FORMER GREGGS FACTORY, TWICKENHAM RESIDENTIAL & INDUSTRIAL

STAGE 1 RSA DESIGNERS RESPONSE

PROJECT NO. 3760/1180 DOC NO. TN005

Stage 1 Road Safety Audit

APPENDIX A - PROBLEM LOCATION PLAN

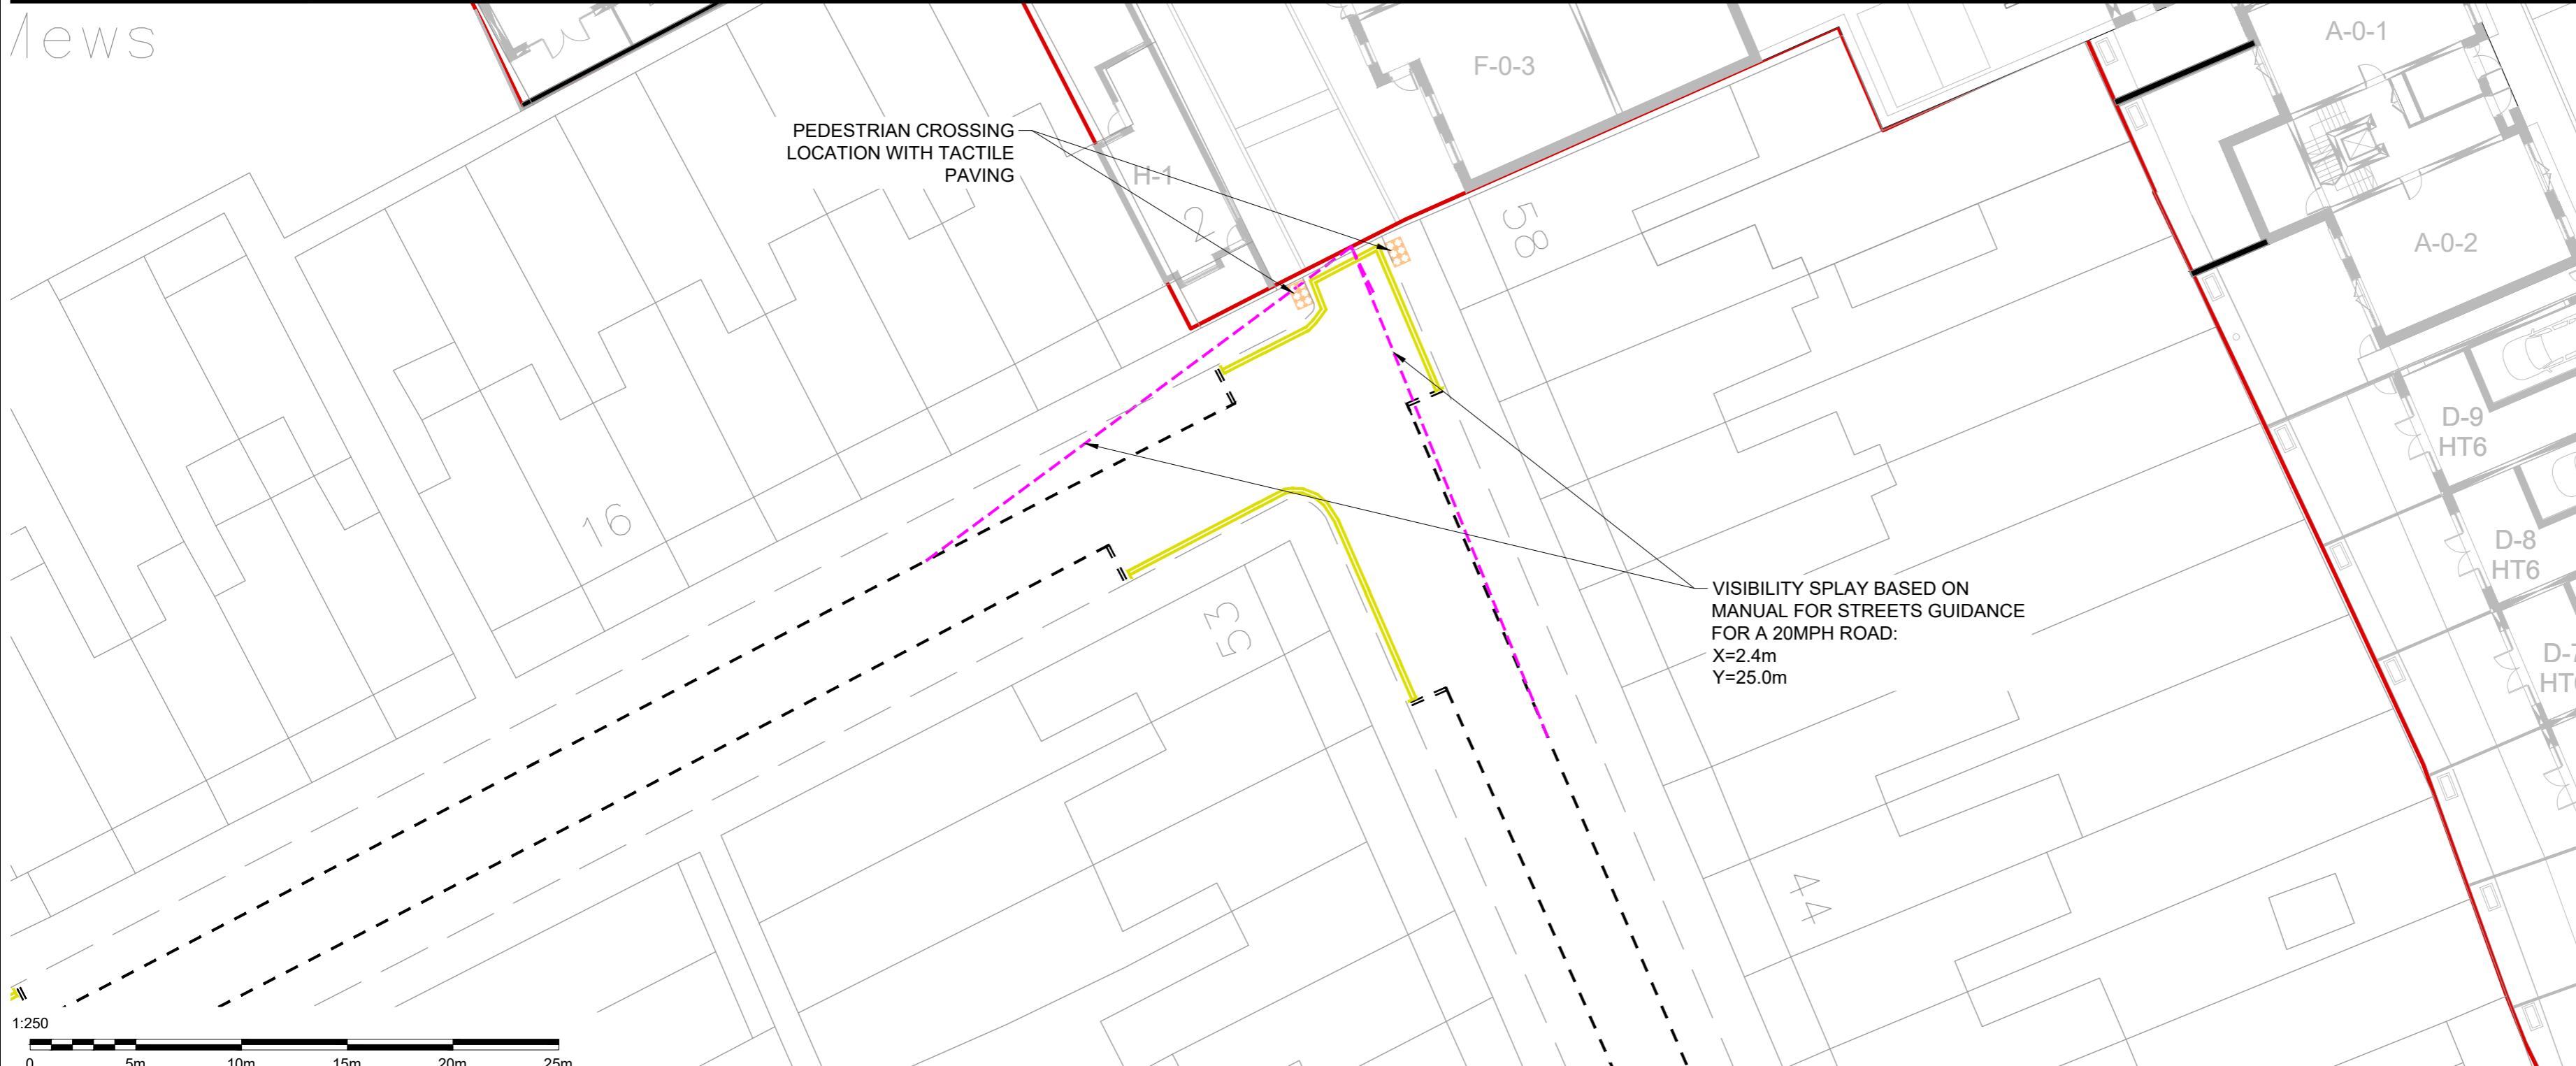
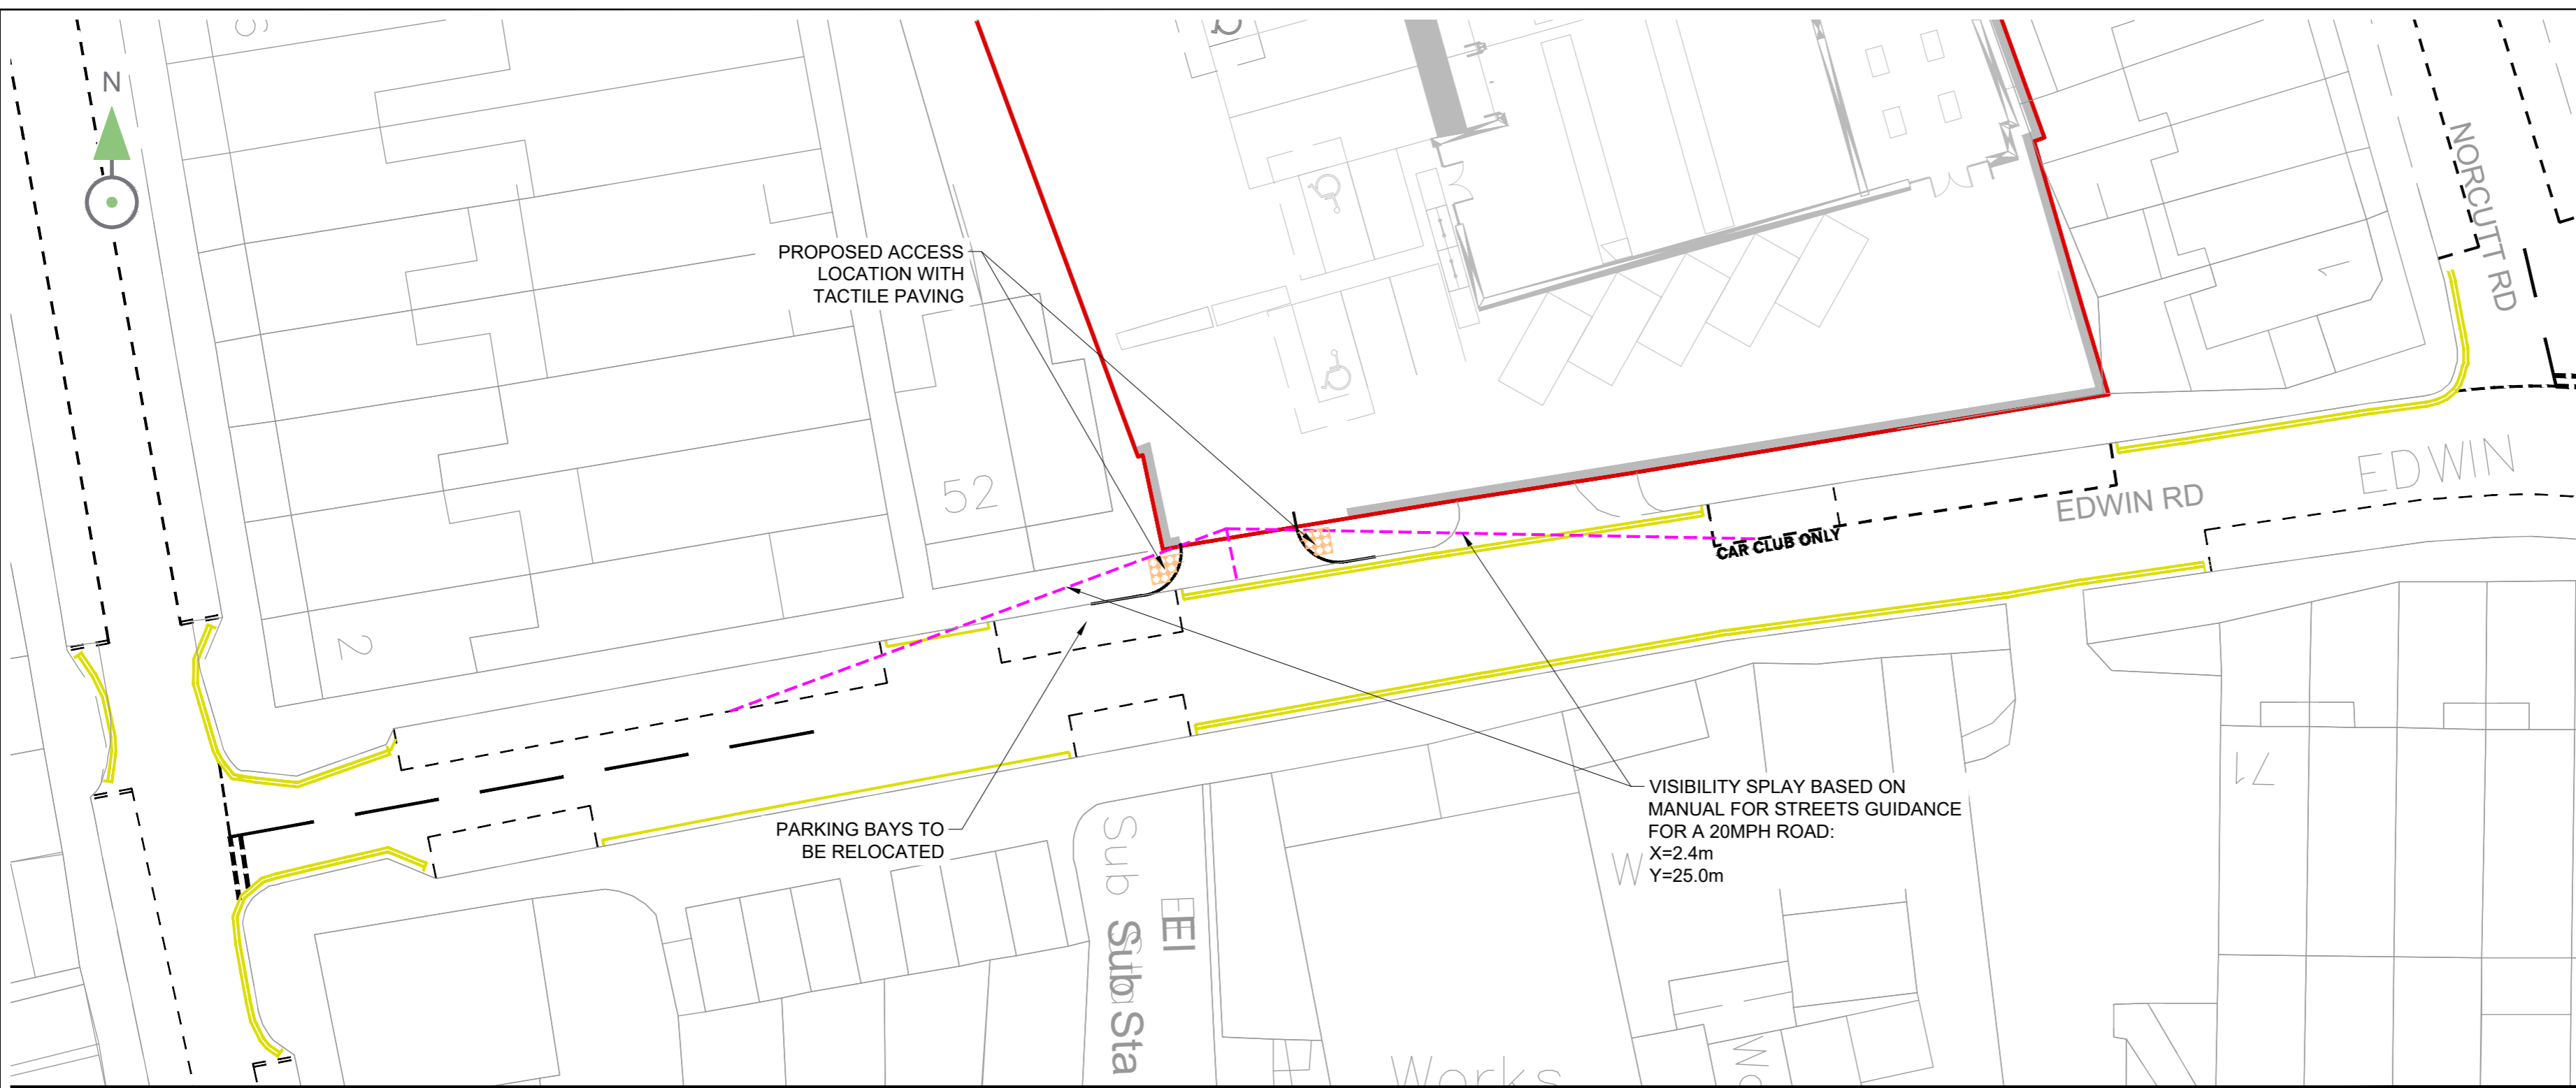
Locations 1, 2, 3 & 4 - Within the alignment of the proposed residential development site access road (Drawing No. GBT-ASA-ZZ-00-DR-A-0250).

The scheme drawing indicates the presence of proposed tree planting at the locations indicated. When fully mature, the proposed trees could impact upon forward visibility for drivers travelling in the north bound, west bound and south bound directions through the development site.

Concern arises that this situation could lead to a potential increased risk of head-on type vehicular collisions occurring or offside to offside type vehicular collisions occurring within the access road between opposing flows of vehicular traffic, whereby vehicle occupants could sustain personal injury.

In addition, the forward visibility impacted upon by the presence of the proposed trees could lead to a potential increased risk of vehicular collisions occurring with pedestrian and pedal cyclists within the shared area, whereby pedestrians and pedal cyclists could sustain personal injury.

It is Recommended that the proposed trees should be omitted or relocated, in order to ensure that a drivers forward visibility to opposing flows of vehicular traffic and to oncoming pedestrians and pedal cyclists is optimised.

Locations 5 & 6 - The proposed residential development site access road priority T-junctions with Edwin Road and Crane Road/Gould Road (Drawing Nos. 3760-1180-T-053 Rev B & GBT-ASA-ZZ-00-DR-A-0250).

The visibility splays are shown as being measured to the centre of the Edwin Road and Crane Road/Gould Road carriageways and not the effective edges of the vehicular carriageways, which are the longitudinal carriageway markings which form and delineate the on-street parking bays. In effect, this results in a “y” distance which is less than the required minimum of 25 metres.

Concern arises that this situation could result in a potential increased risk of side impact vehicular collisions occurring between vehicles exiting the junctions and vehicular traffic in the Edwin Road and Crane Road/Gould Road carriageways, whereby vehicle occupants could sustain personal injury.

It is Recommended that the proposed visibility splays should be measured to the effective edges of the vehicular carriageways, which are the longitudinal carriageway markings which form and delineate the on-street parking bays.

Locations 7 & 8 - The proposed residential development site access road priority T-junctions with Edwin Road and Crane Road/Gould Road (Drawing Nos. 3760-1180-T-053 Rev B & GBT-ASA-ZZ-00-DR-A-0250).

Concern arises as to how pedestrians leaving the footways in Edwin Road and Crane Road/Gould Road will enter the proposed development site as suitable and appropriate facilities have not been indicated. As there does not appear to be a form of tie-in between the footways of Edwin Road and Crane Road/Gould Road and the proposed development site access road, concern arises that there could be a potential increased risk of pedestrian and vehicular collisions occurring, whereby pedestrians could sustain personal injury.

It is Recommended that the existing footways in Edwin Road and Crane Road/Gould Road should tie-into the overall shared area width of 6.8 metres of the development site access road and that the pedestrian access routes are clearly defined, in order to ensure that pedestrian safety is not compromised in the future scenario.

- 3.2.8 The RSA comment on the forward visibility within the site is noted, and the location of the trees will be reviewed as part of Stage 2 on-site design with the view to relocating the trees where possible.

- 3.2.9 As part of the proposed design, the internal mews road through the site has incorporated a shared-use approach to encourage lower vehicular speeds, focus driver attention and offer priority for non-motorised users. There are a number of additional design interventions which have been employed on the north-south mews street to reinforce the shared-surface approach and hierarchy of users, such as planters and landscaping features located along the western side, adjacent to the mews houses.

- 3.2.10 These design interventions result in an environment where low speeds are encouraged, non-motorised users have priority and where there is sufficient space to allow different users to safely navigate the road. In the Department for Transport publication Manual for Streets (DfT 2007), the utilisation of planting is outlined to be a clear benefit in softening urban street scenes whilst acting to "limit forward visibility to help reduce vehicle speeds" (see MfS section 5.12).

- 3.2.27 The proposed development will largely retain the two existing access points, albeit with changes to the entry treatment. The proposed entry treatments along both the south and north entrances would reinstate the footway across each access, with the vehicular accesses being akin to Copenhagen-style crossings rather than formal junctions, with pedestrians crossing having the right of way over vehicle traffic.
- 3.2.28 The detailed design of the two accesses and arrangements would still be the subject of an s278 Agreement, detailed design and technical approval. If the preferred entry treatment described above was not accepted, then we proposed to revert to traditional kerbed access, which would incorporate dropped kerbs and tactile paving.
